UNITED STATES PATENT AND TRADEMARK OFFICE

Office Action Summary	Application No. 10/696,463	Applicant(s) LIN ET AL.	
	Examiner TIMOTHY RUDE	Art Unit 2871

DETAILED ACTION

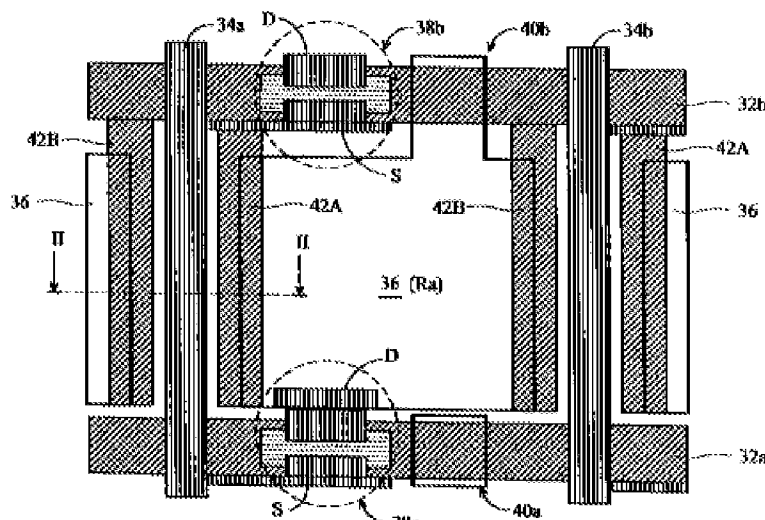
Claim 34 is objected to because of the following informalities: The drain electrode does NOT traverse a spacing between the first shielding layer and the second shielding layer as claimed. The pixel electrode does.

For examination purposes, examiner will consider overlap and traverse by the pixel electrode per elected embodiment as shown in Figure 3E.

Appropriate correction is required.

FIG. 3E

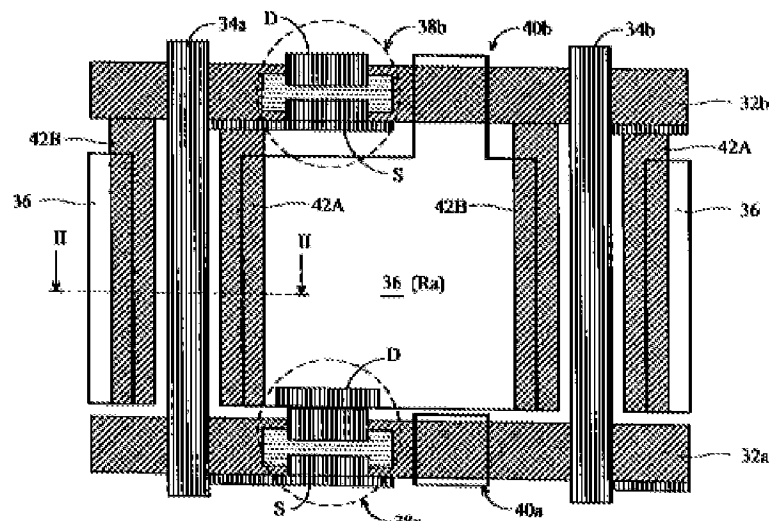
Applicant elected and has received numerous office actions on the merits of embodiment one as shown in Applicant's Figure 3E:

However, Applicant received an office action rejecting claims that read on the device as shown in Figure 6. Therefore, both species are considered.
